## ADDENDUM

**ADDENDUM NO.:** 04  
**PROJECT NAME:** Emiliano Zapata Academy Annex  
**PROJECT NO.:** 05055  
**CONTRACT NO.:** C1580  
**DATE OF ISSUE:** September 1, 2017

### NOTICE OF CHANGES, MODIFICATIONS, OR CLARIFICATIONS TO CONTRACT DOCUMENTS

DRAWING NO.  
**EX1.0**

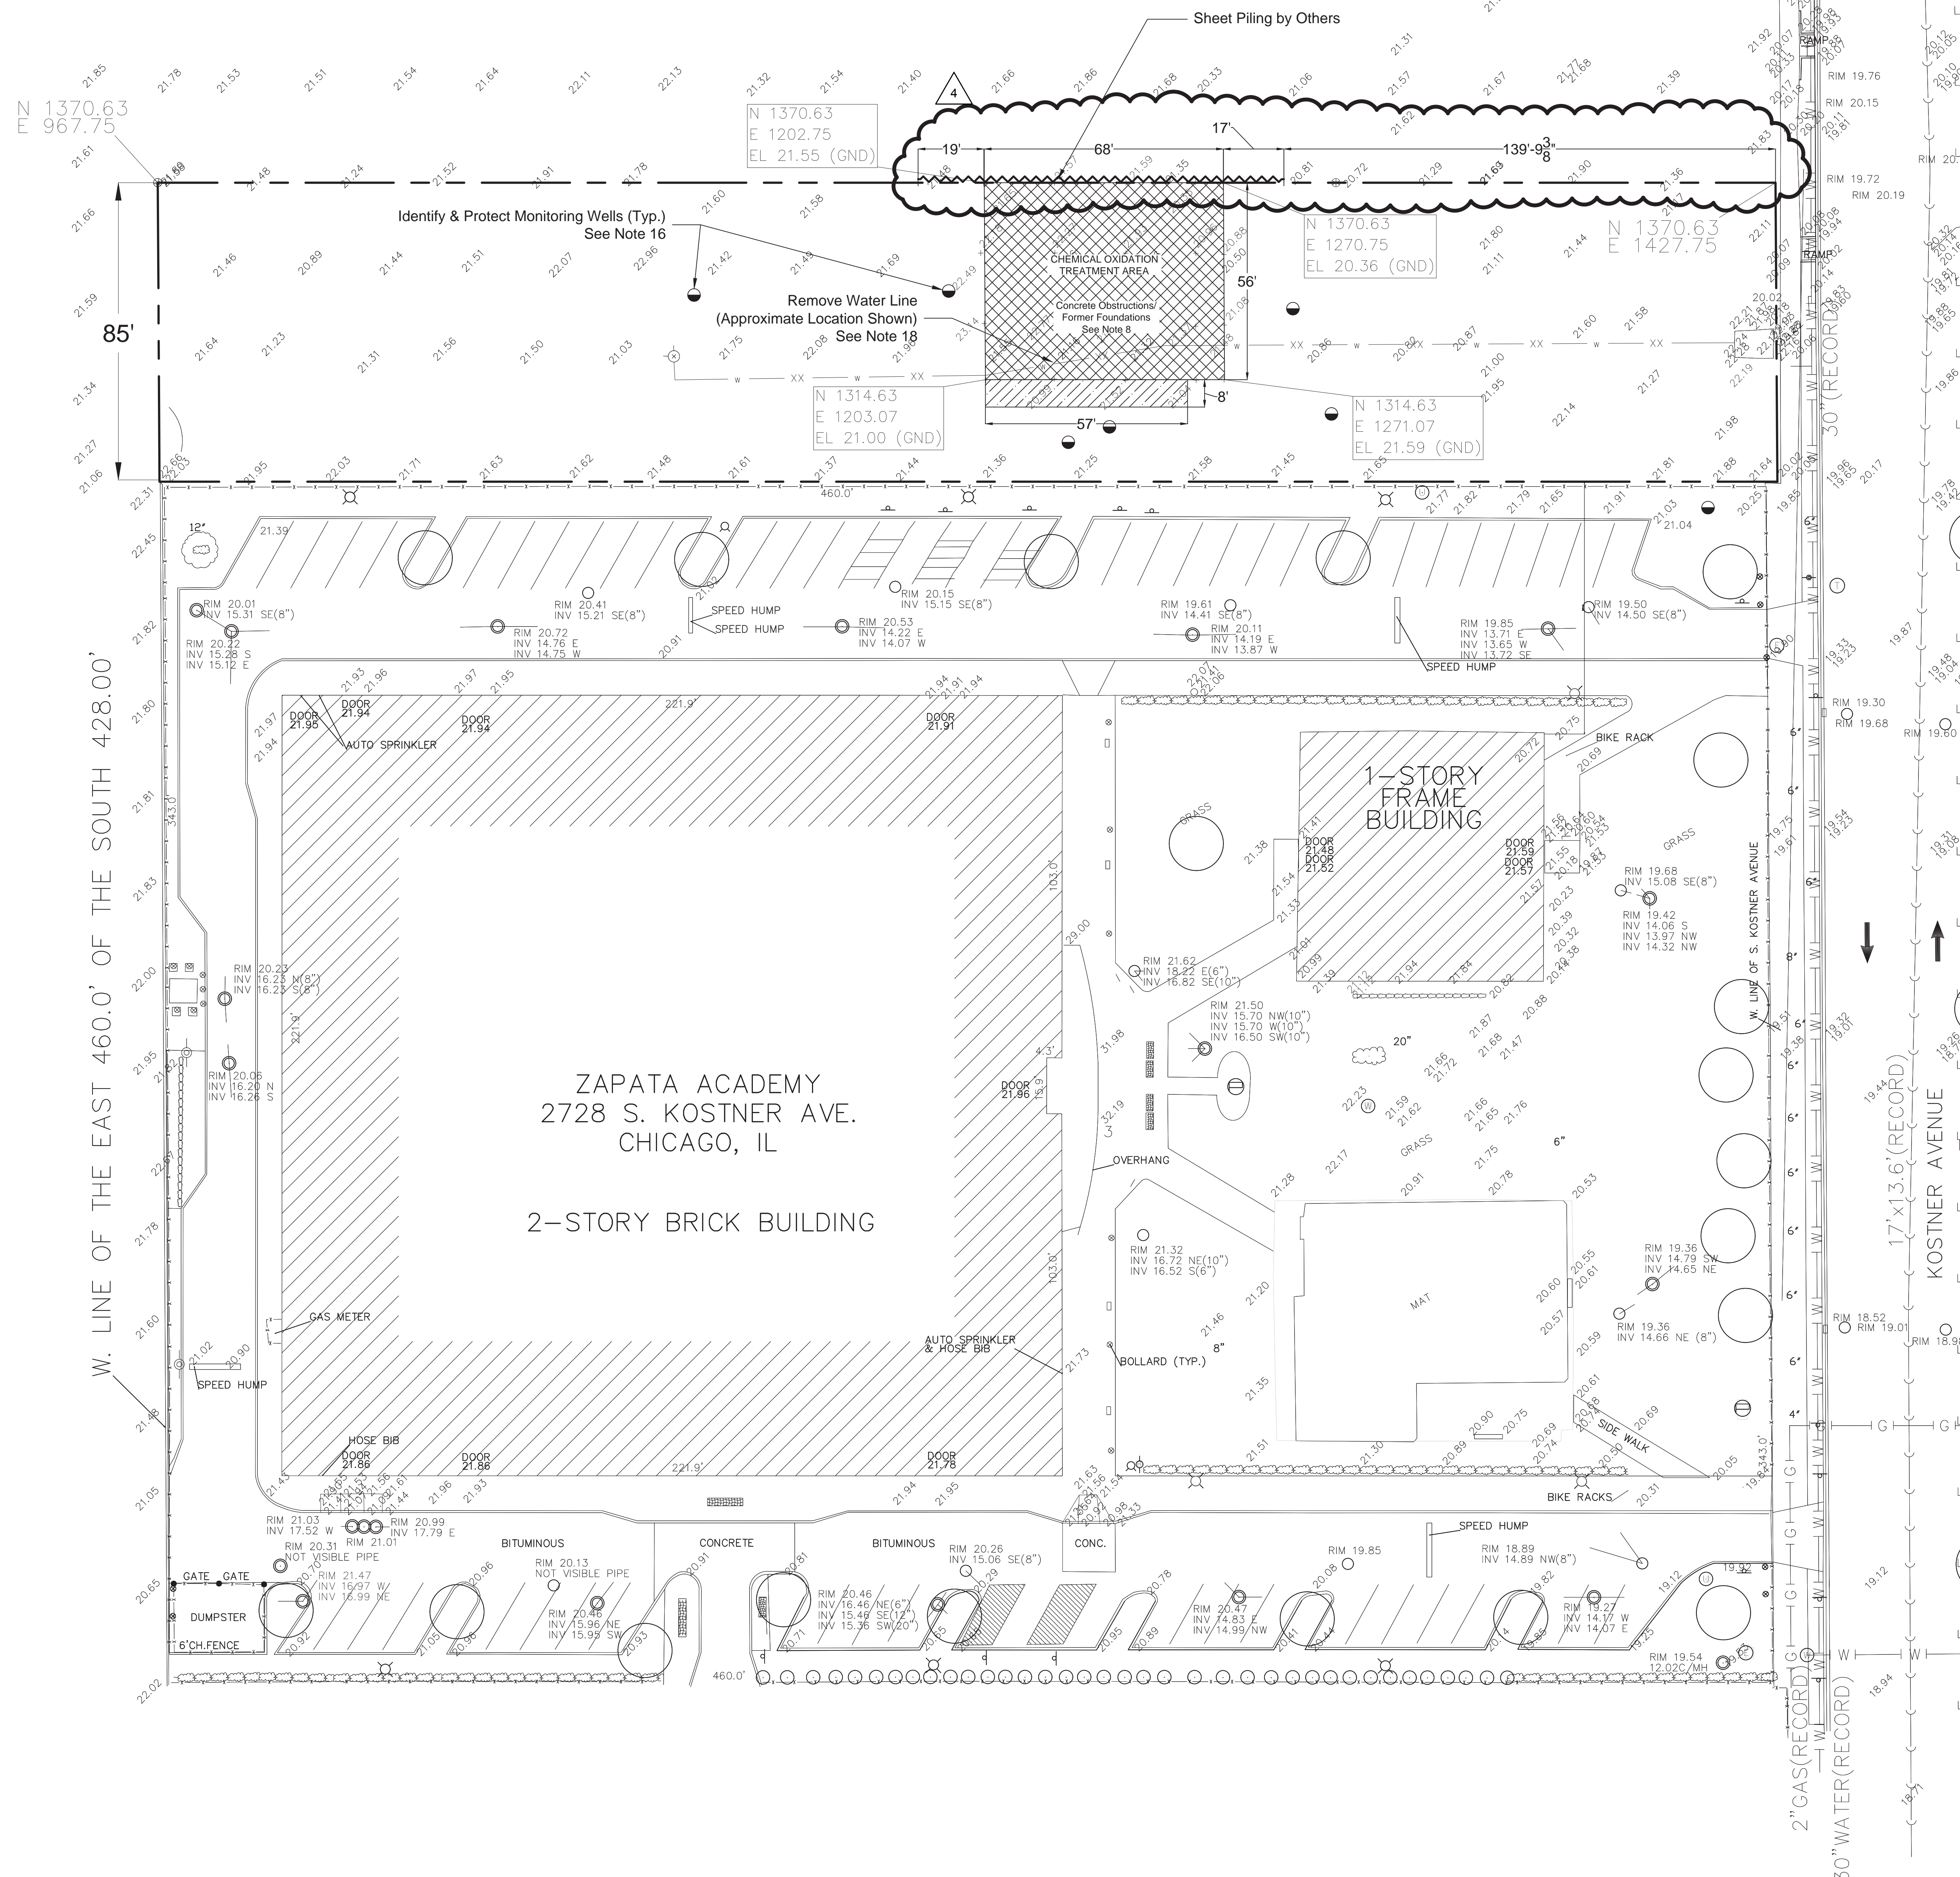
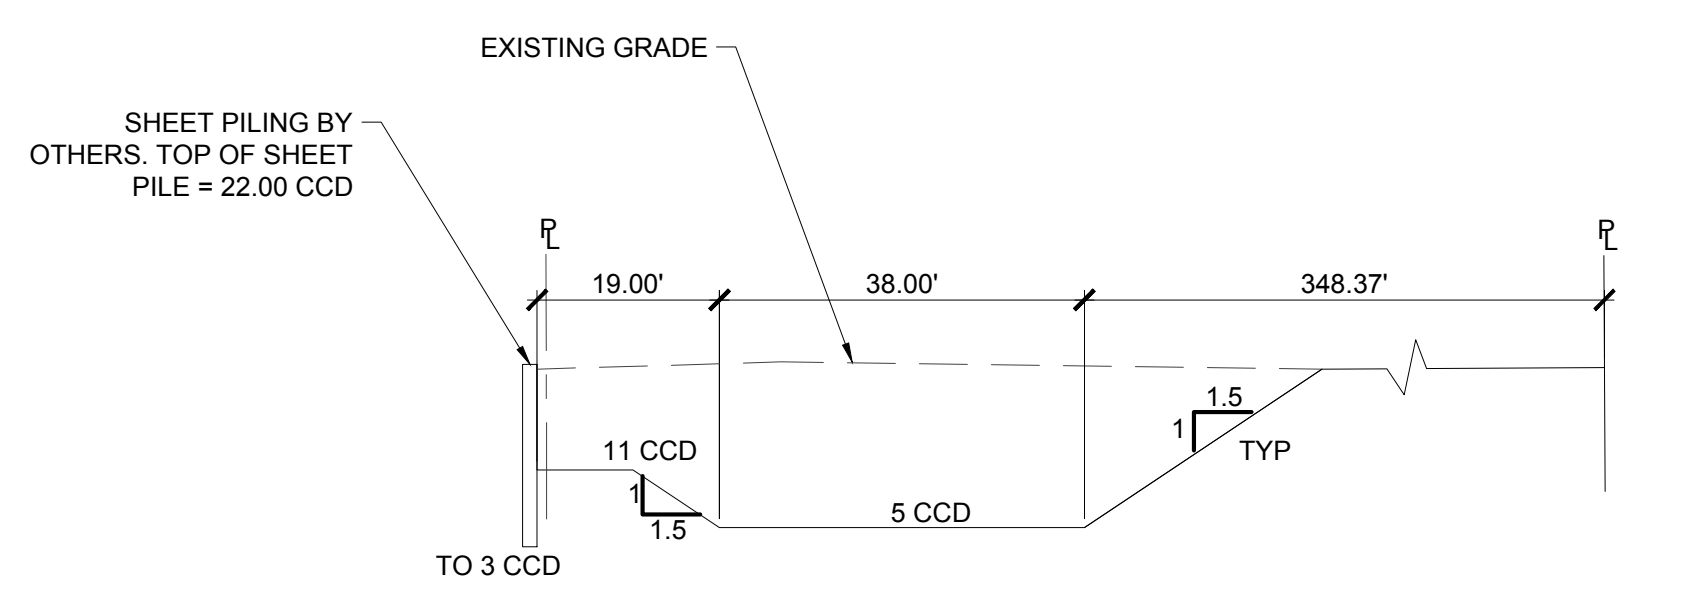
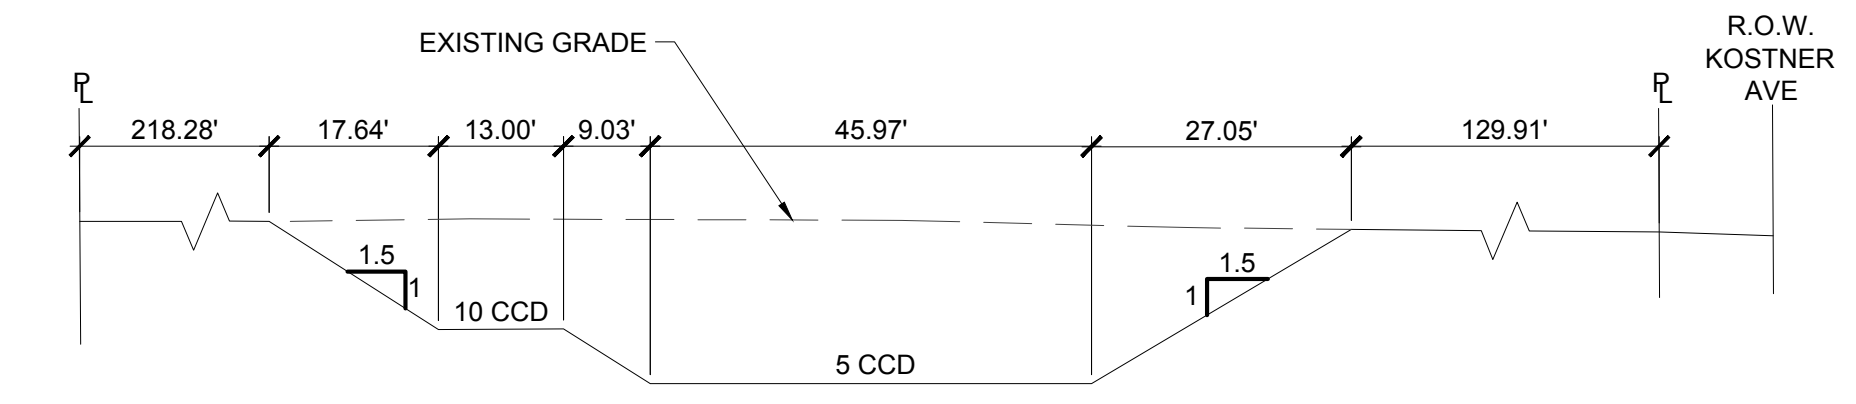
- Change 9.** SHEET EX1.0 Excavation Plan – **REVISED** sheet in its entirety to coordinate with CDOT and sheet pile wall being installed by others.

**EX2.0**

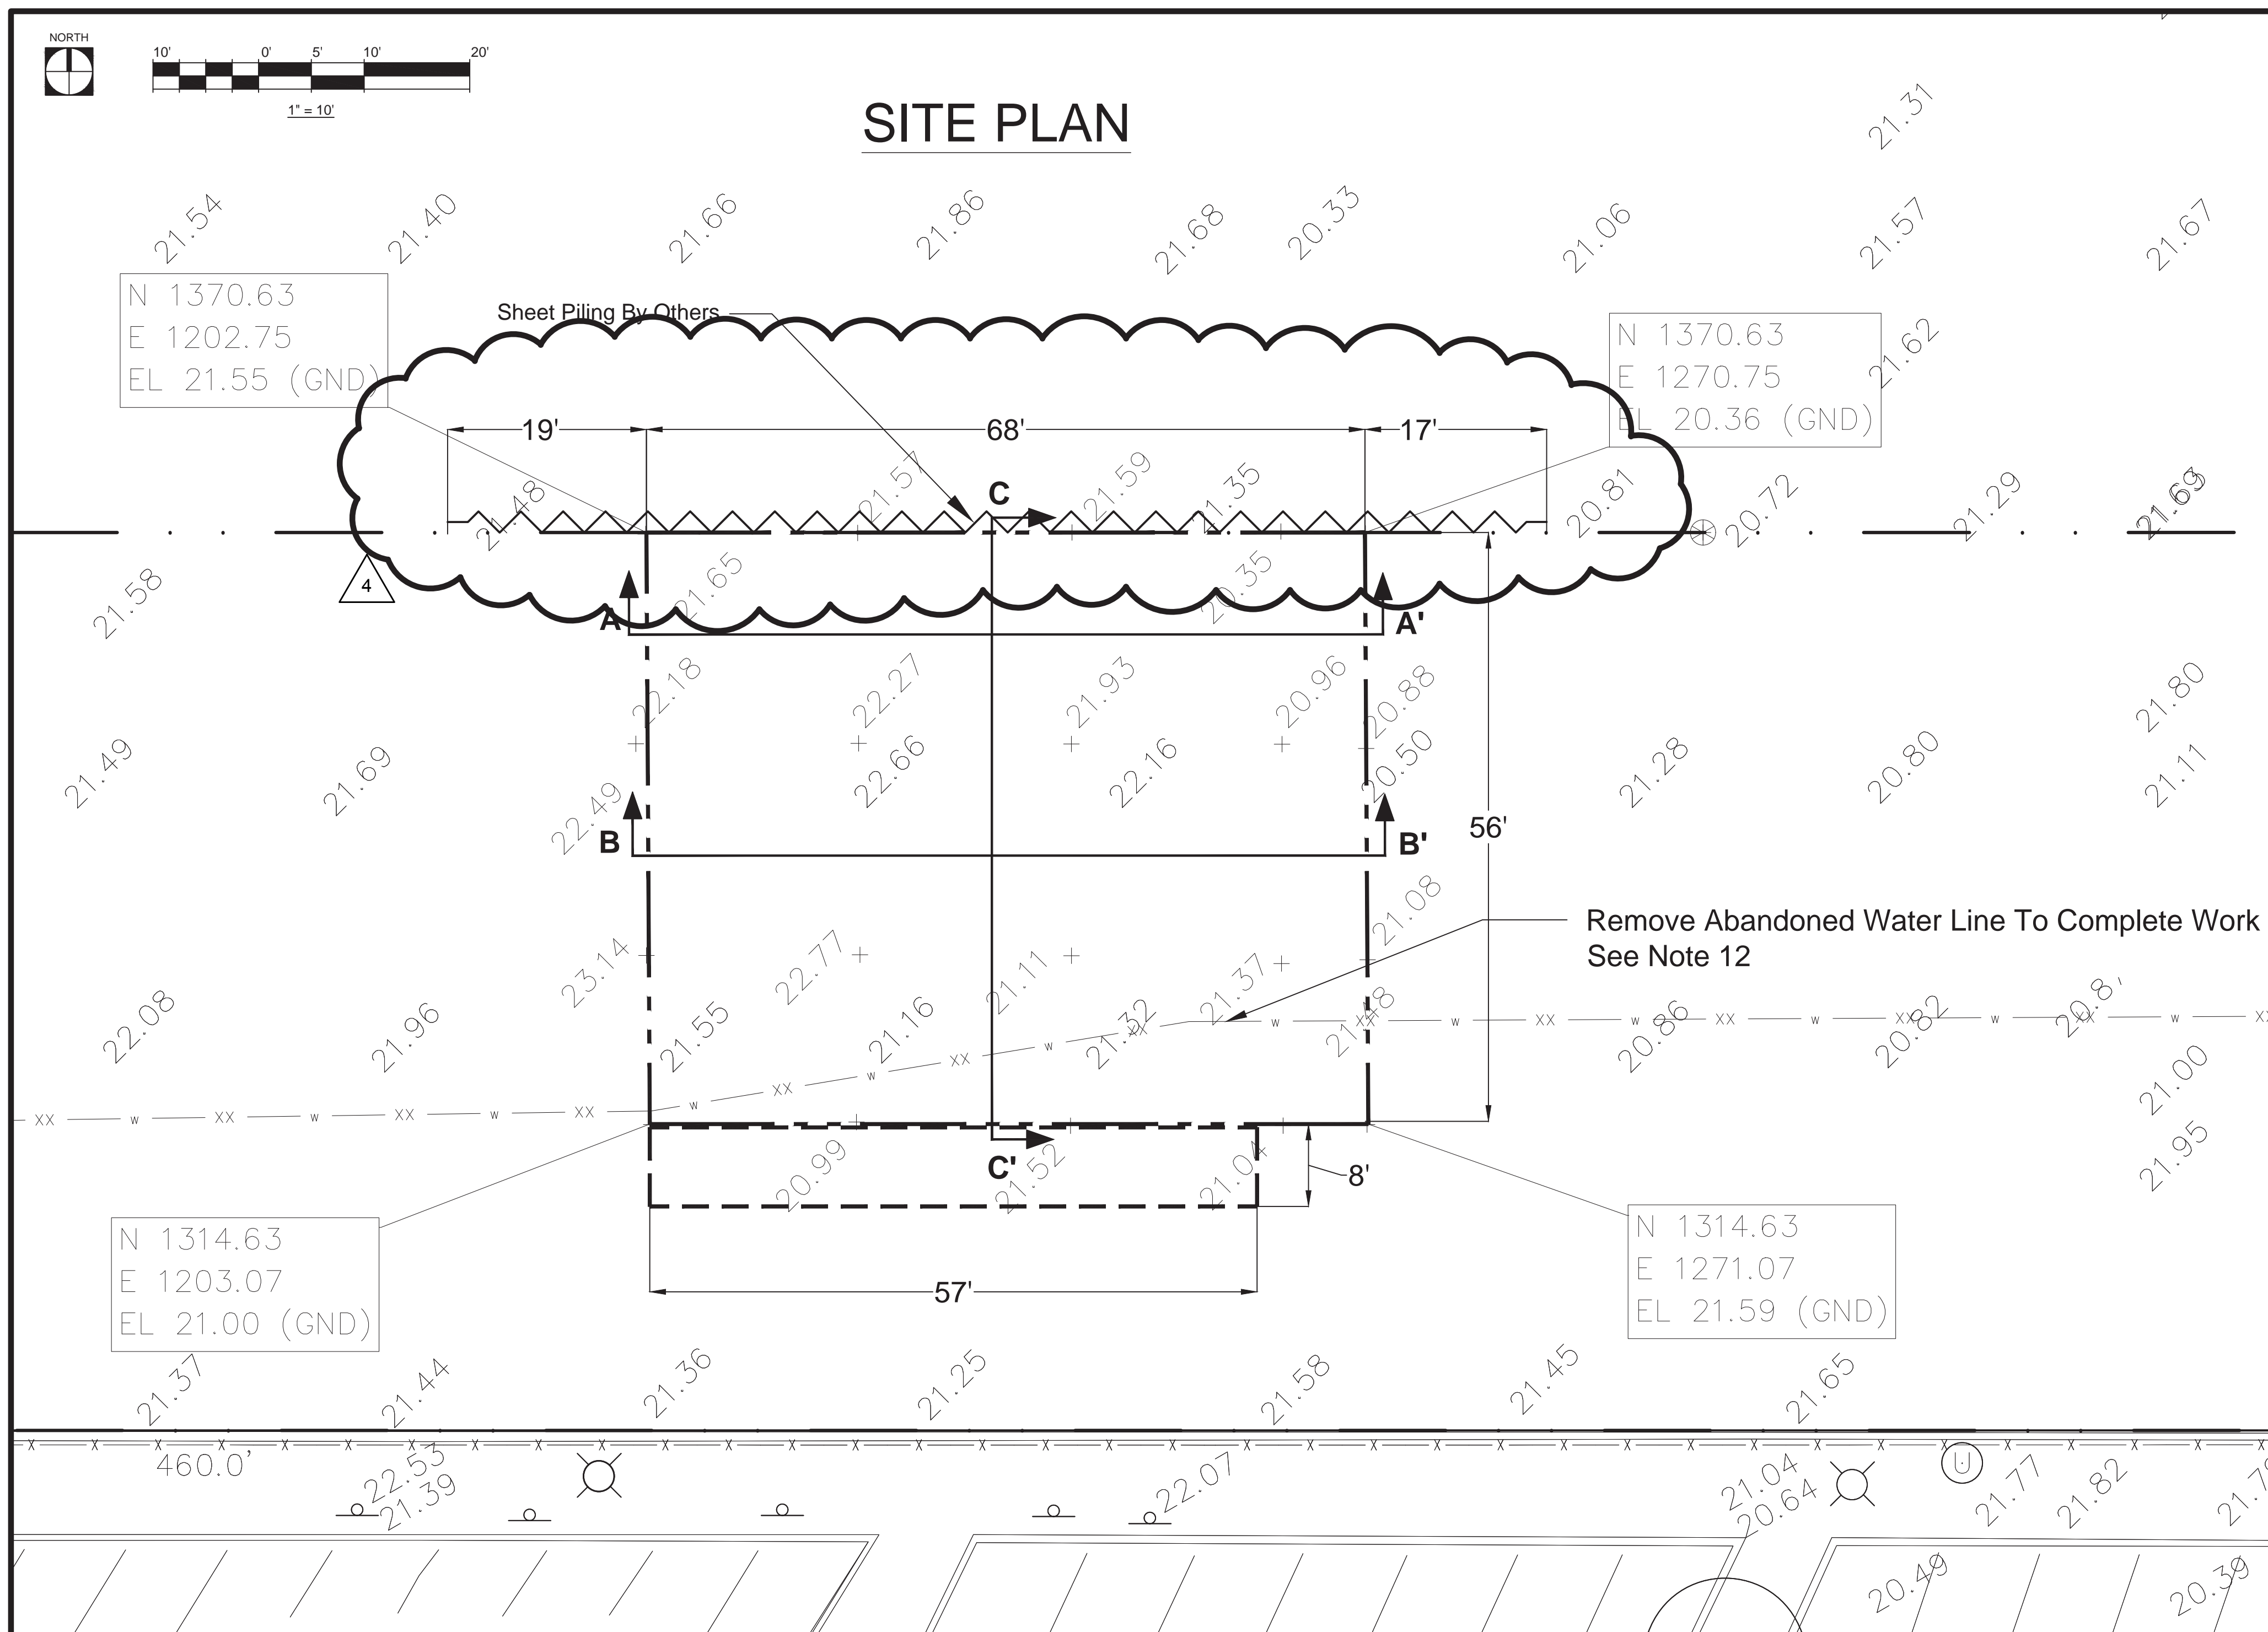
- Change 10.** SHEET EX2.0 Treatment Area Site Plan – **REVISED** Dimensions of sheet pile wall location and extents that is being provided and installed by others.
- Change 11.** SHEET EX3.0 Chemical Oxidation Treatment – **REVISED** dimensions of sheet pile wall location and extents that is being provided and installed by others.
- Change 12.** SHEET S1.0 Foundation Plan – **ADDED** Keynote #8 at 4 locations.
- Change 13.** SHEET ES.1 Electrical Site Plan – **REVISED** Keynote #9
- Change 14.** SHEET ES.1 Electrical Site Plan – **ADDED** Keynote #10 and provisions for new telecommunications duct bank.
- Change 15.** SHEET E7.8 Electrical Details – **ADDED** Detail 4 Duct Bank Detail
